**Proposed ‘House (not elsewhere specified)’ Development and Proposed Minor Relaxation of Maximum Plot Ratio Restriction in “Residential (Group D)” Zone at Lots Nos. 407 S.A ss.2 S.A and 408 S.B ss.1 RP in D.D. 94, Hang Tau Tai Po, Kwu Tung South, New Territories (Application No.: A/NE-KTS/538) – Further Information**

**Proposed ‘House (not elsewhere specified)’ Development and Proposed Minor Relaxation of Maximum Plot Ratio Restriction in “Residential (Group D)” Zone at Lots Nos. 407 S.A ss.2 S.A and 408 S.B ss.1 RP in D.D. 94, Hang Tau Tai Po, Kwu Tung South, New Territories (S.16 Planning Application TPB Ref: A/NE-KTS/538)**

**Figure 5b - Master Layout Plan**

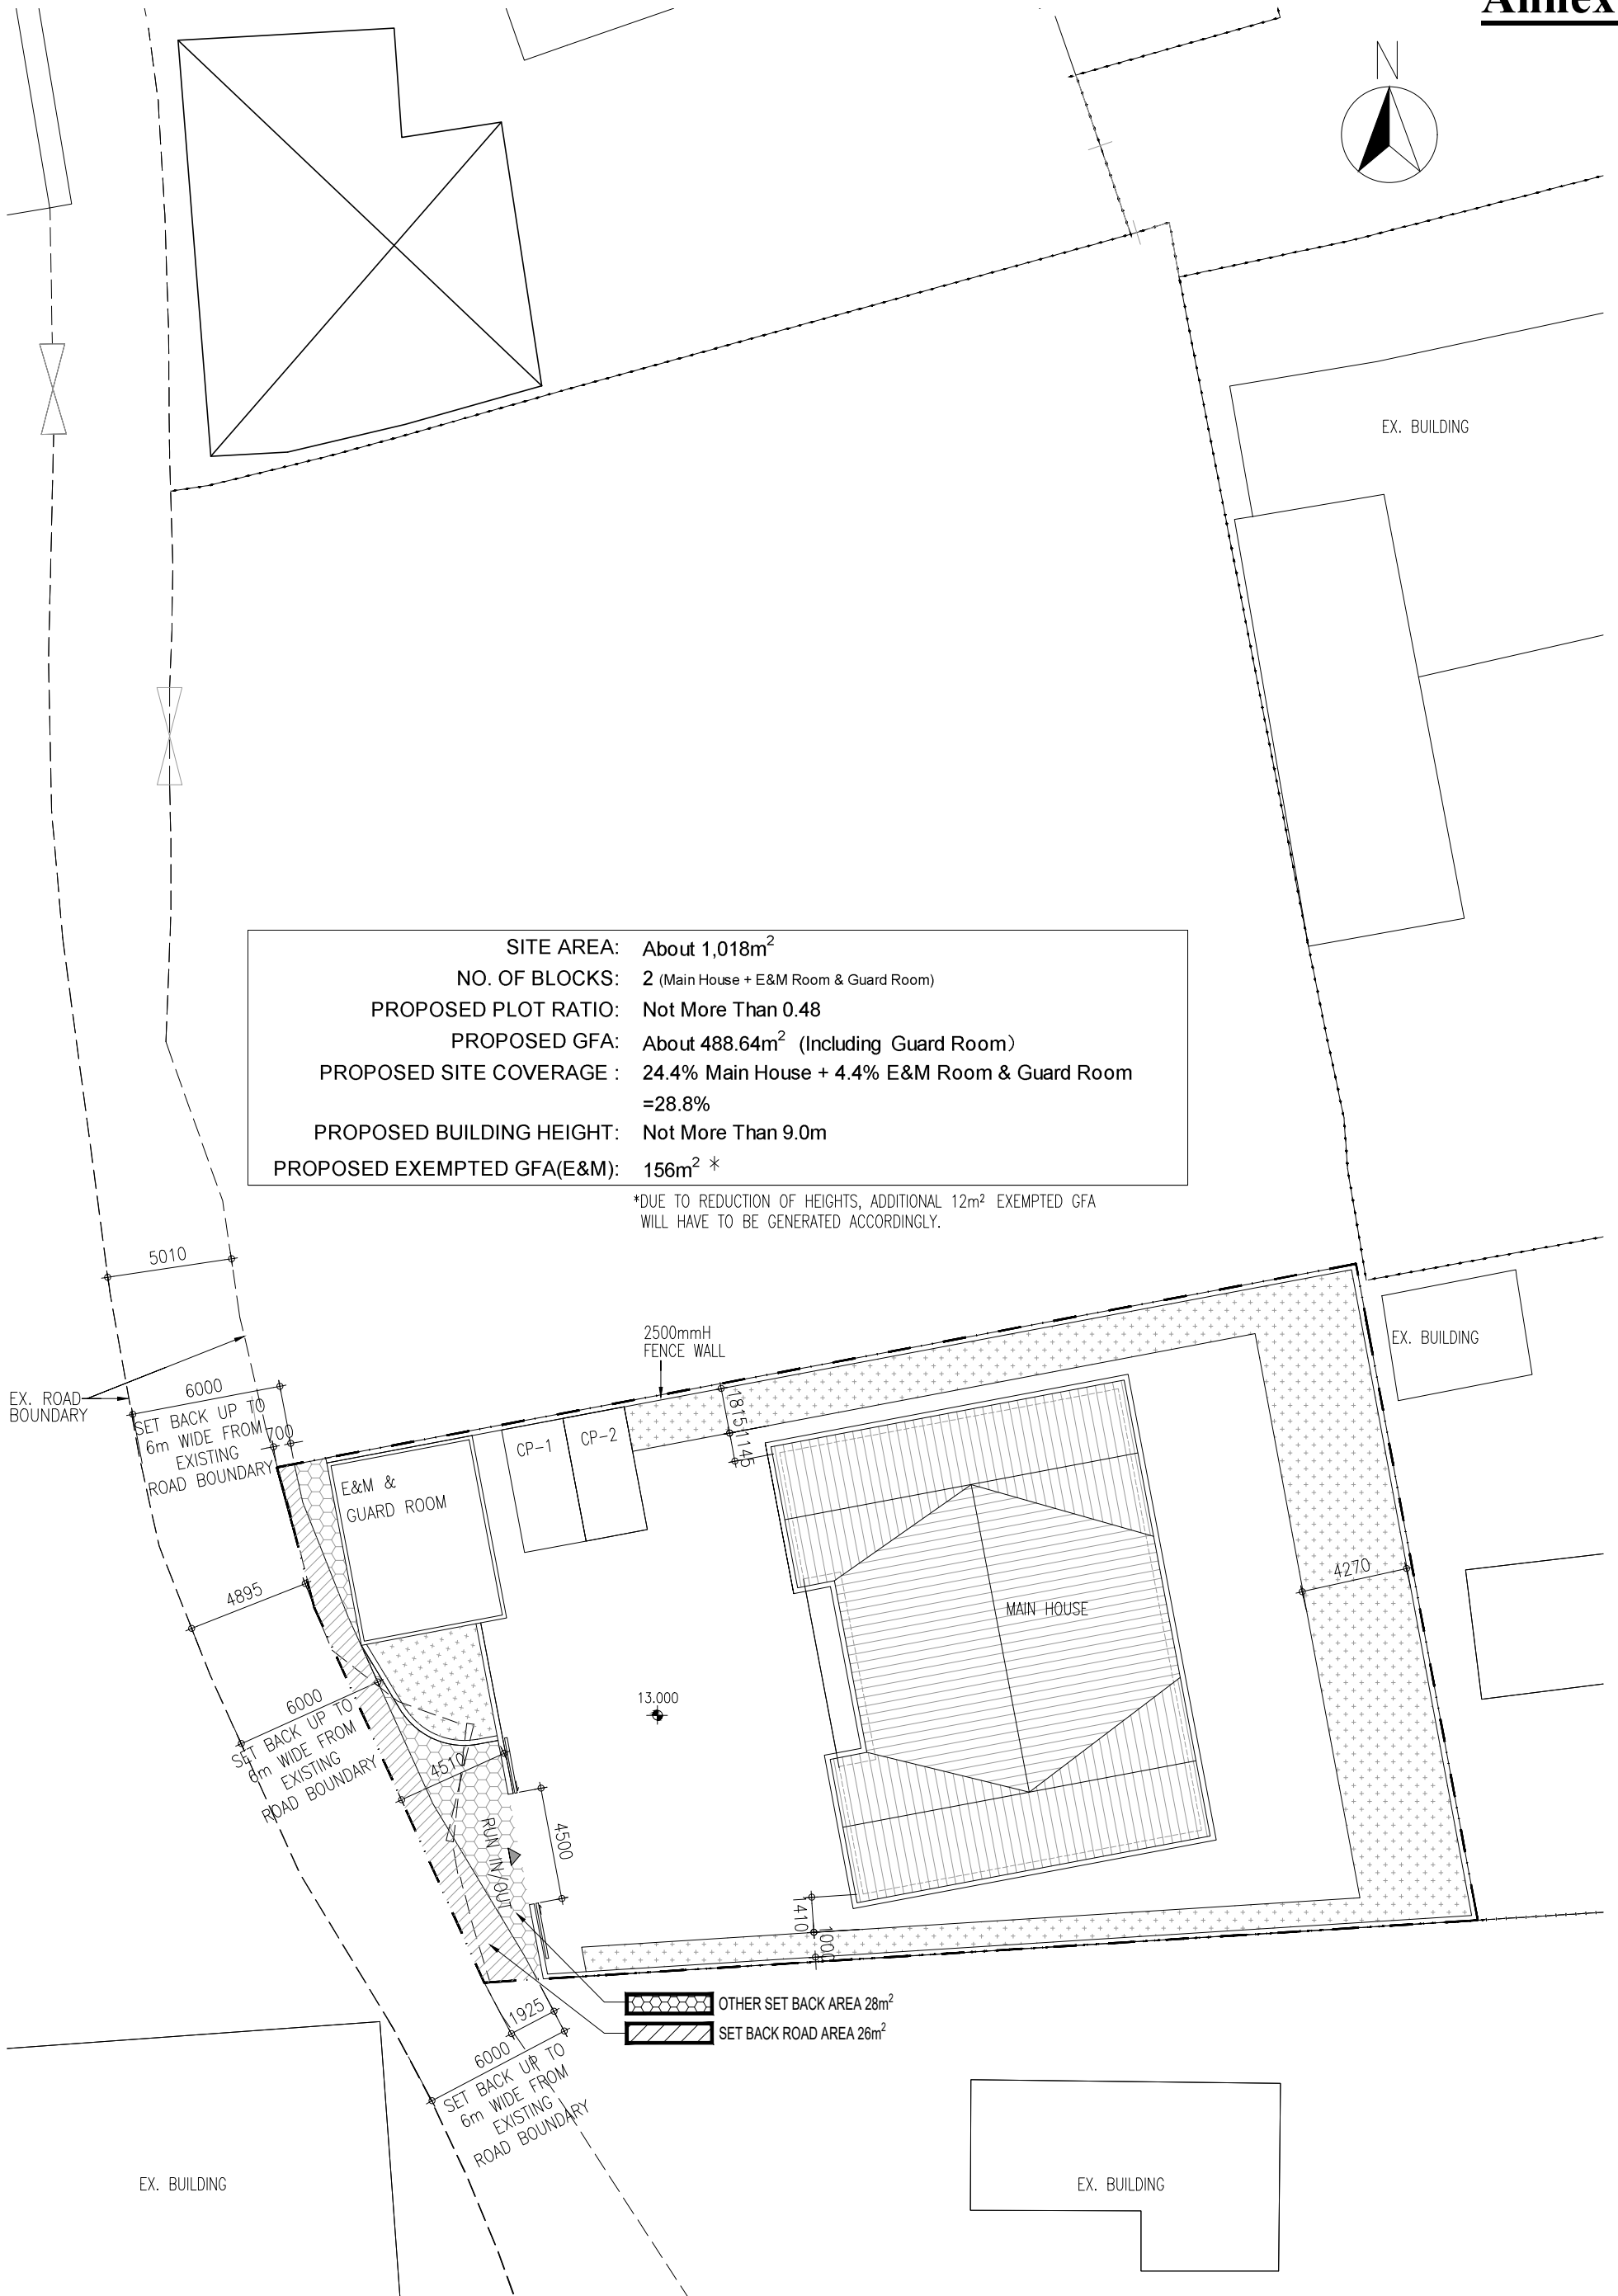
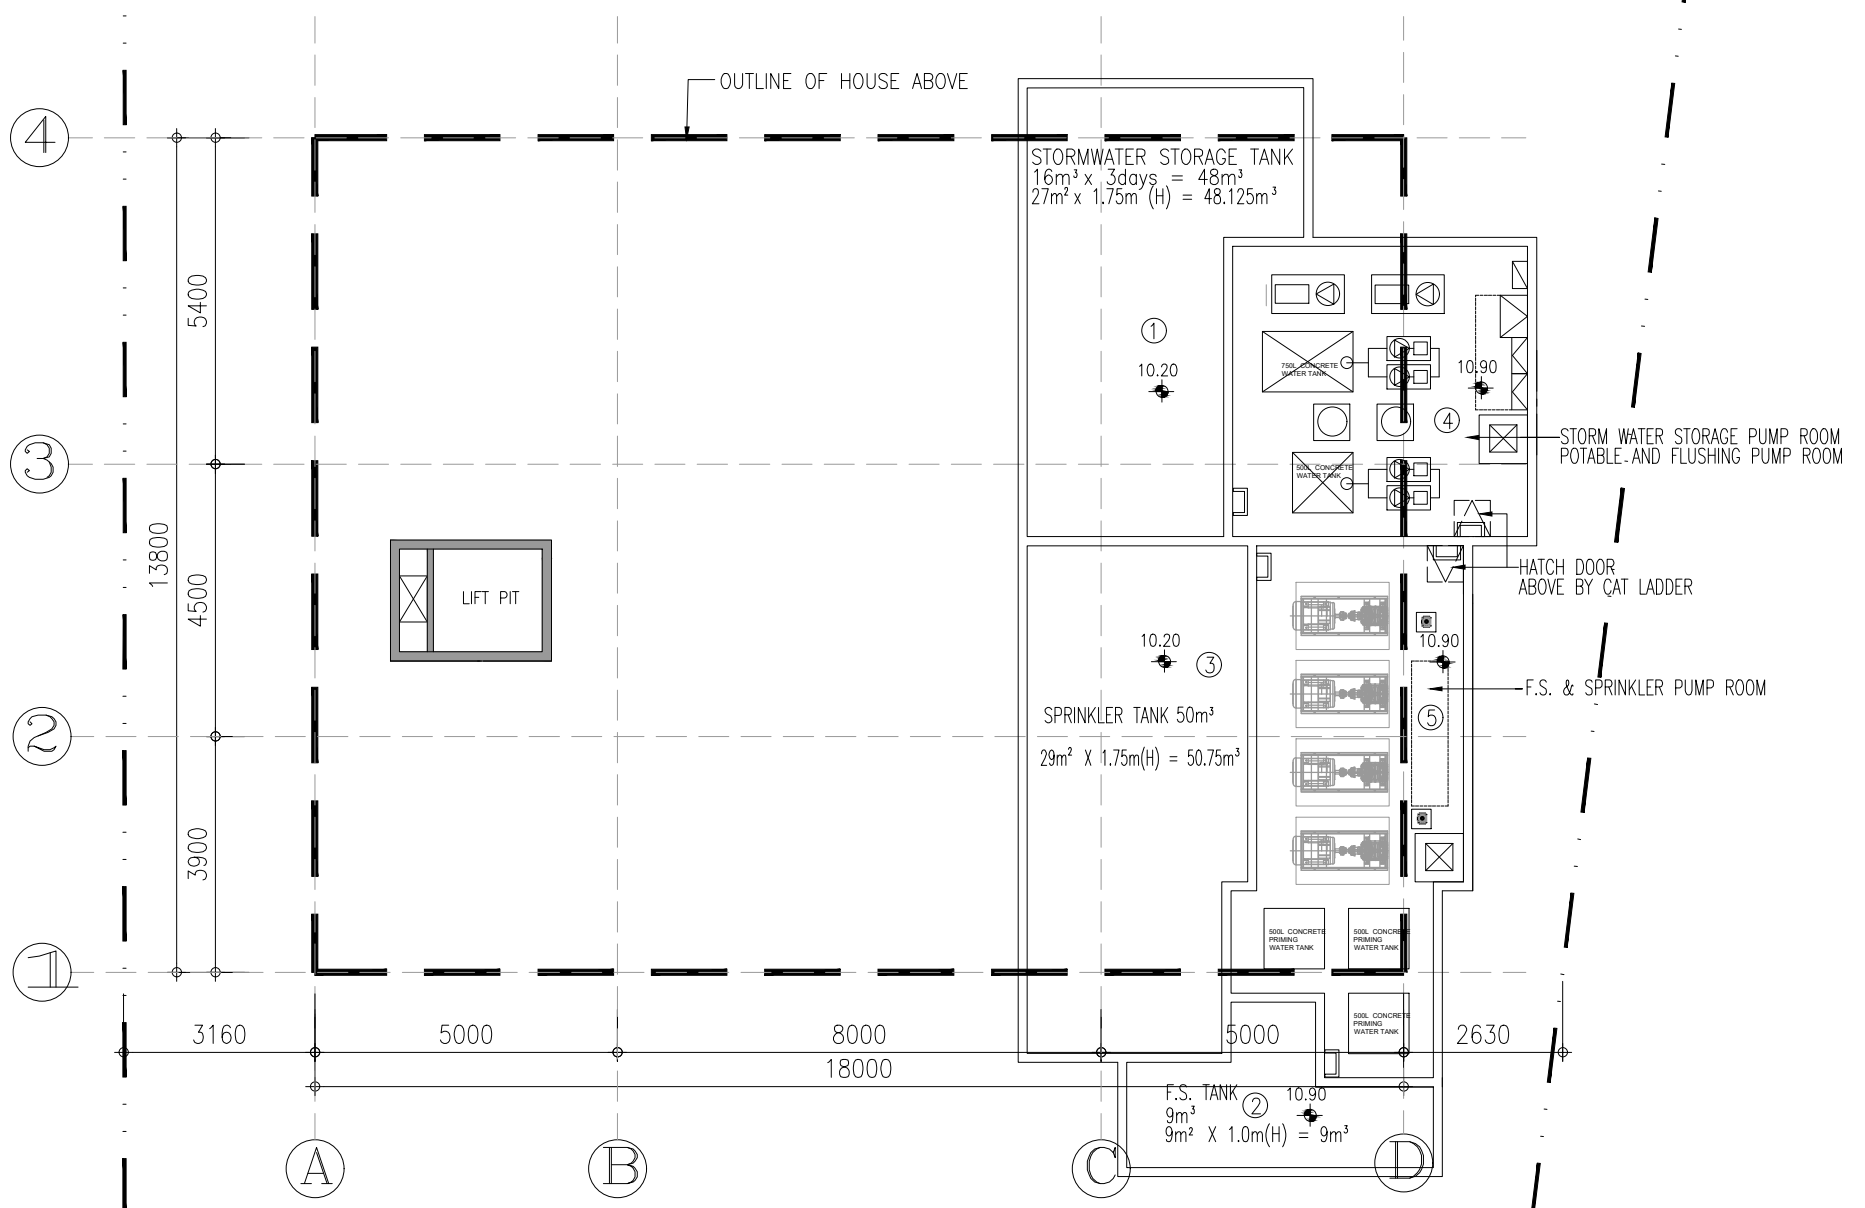
1.	<p>The Applicant proposed in the FI a new setback area named for "self-circulation purposes" in para. 2b of its cover letter dated 11.6.2024 and marked it as "other set back area 28m<sup>2</sup>" in the revised Figure 5a – Master Layout Plan. The Applicant shall clarify the meaning of "self-circulation purposes", i.e. whether the said “other set back area 28m<sup>2</sup>” is intended to be surrendered to the Government (i.e. likewise as the “set back road area 26m<sup>2</sup>”), and its management and maintenance responsibilities.</p>	<p>The Applicant would like to confirm that it has no intention to surrender the “other set back area of 28m<sup>2</sup>” to the Government. This portion of the set back area will be designed, constructed, maintained and managed by the Applicant on its own expenses.</p>

2.	<p>Regardless of the Applicant’s clarification of its intention, we note TD’s comments from the Response-to-Comments that widening the short section of access road in this case would only bring insignificant traffic benefits to the road users in the community. As mentioned in our previous memo dated 3.6.2024, in the absence of the concerned bureau / department’s request or support, <u>no conditions for road widening works would be incorporated under lease</u> of the regrant lot of the land exchange application (if submitted).</p>	<p>Noted.</p>

\*DUE TO REDUCTION OF HEIGHTS, ADDITIONAL 12m<sup>2</sup> EXEMPTED GFA WILL HAVE TO BE GENERATED ACCORDINGLY.

OTHER SET BACK AREA 28m<sup>2</sup>  
 SET BACK ROAD AREA 26m<sup>2</sup>

**Figure 6b - Underground E&M Utilities Room Plan**

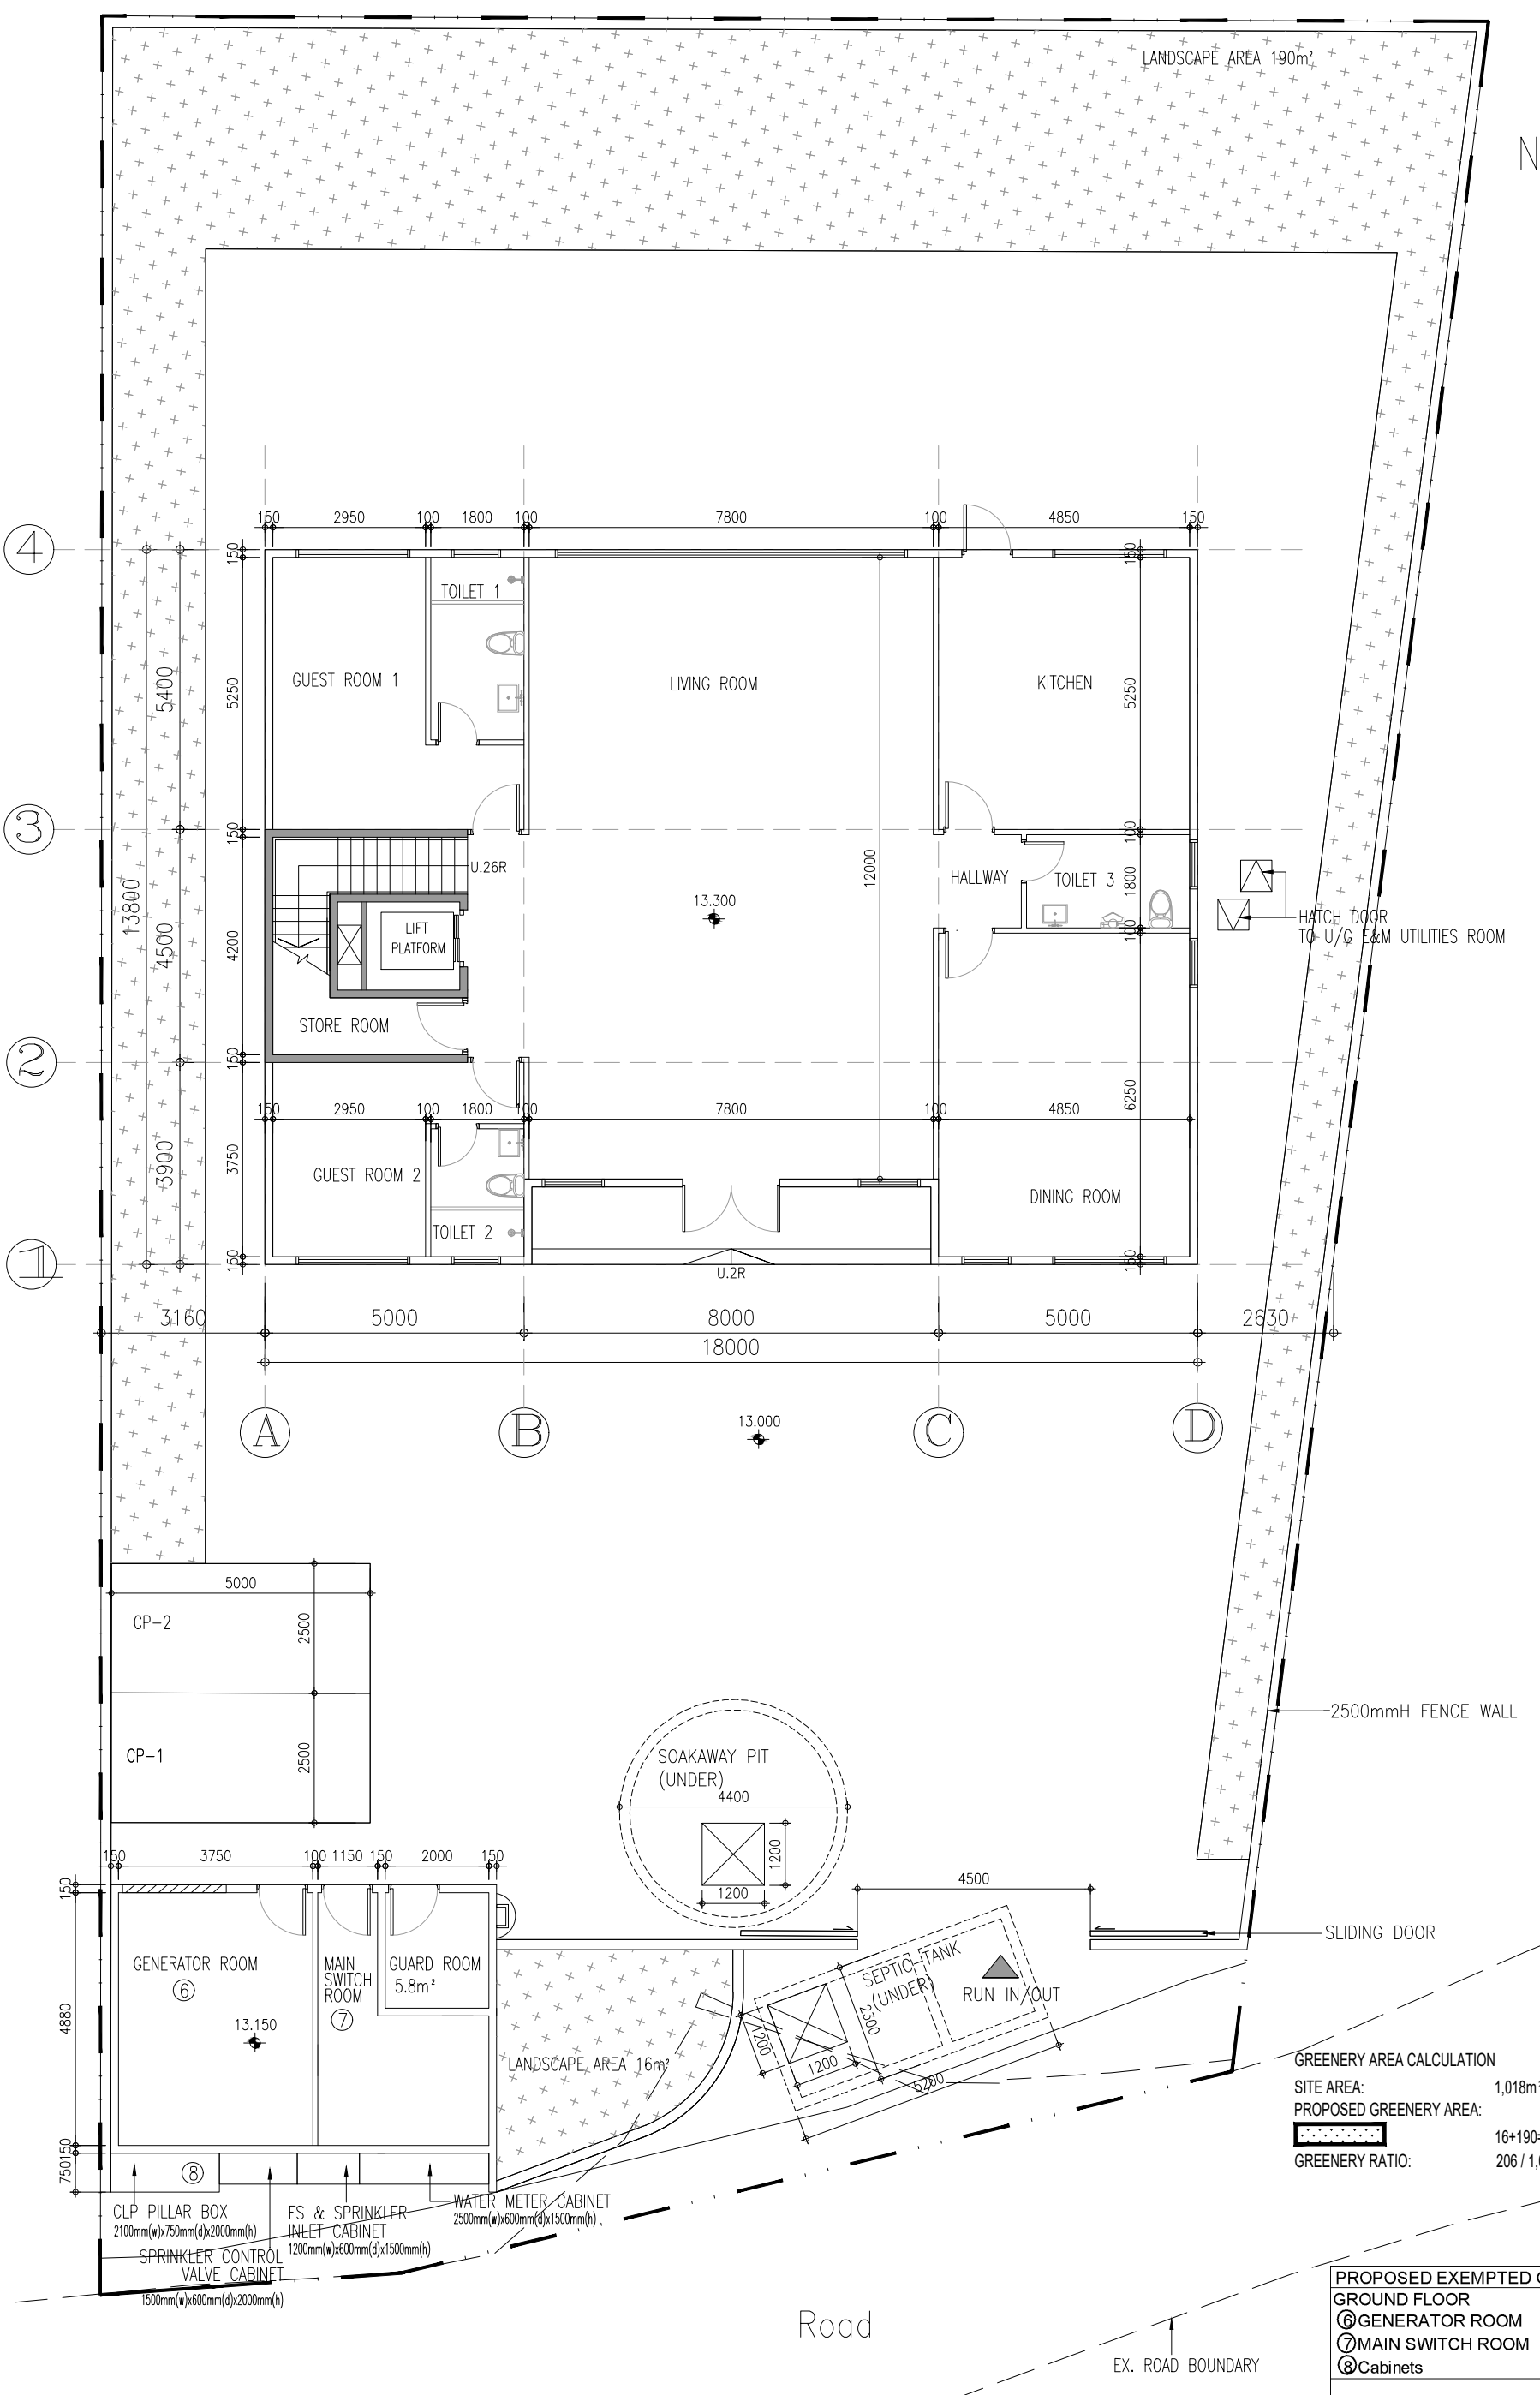
1.	<p>Based on the information provided, in particular of the height, the underground E&amp;M facilities and water tanks may be considered as a storey under the Buildings Ordinance.</p>	<p>The proposed heights of the F.S. &amp; sprinkler pump room, stormwater storage pump room and portable &amp; flushing pump room have been reduced to 2.1m, while the height of the stormwater storage tank, F.S. tank and sprinkler tank are now being reduced to 2.8m. Due to the above changes, a set of revised plans, i.e. <b>Figures 5b, 6b, 7a and 11a</b>, is now attached in <b>Annex A</b> to replace their original ones. As a result, the sizes of these ancillary facilities have been amended and an additional GFA of about 12m<sup>2</sup> will be resulted accordingly.</p>

PROPOSED EXEMPTED GFA CALCULATION	
UNDERGROUND	About
① STORMWATER STORAGE TANK	27 m <sup>2</sup>
② F.S. TANK	9 m <sup>2</sup>
③ SPRINKLER TANK	29 m <sup>2</sup>
④ STORM WATER STORAGE PUMP ROOM POTABLE AND FLUSHING PUMP ROOM	24 m <sup>2</sup>
⑤ F.S./SPRINKLER PUMP ROOM	28 m <sup>2</sup>
<b>Total</b>	<b>117 m<sup>2</sup></b>
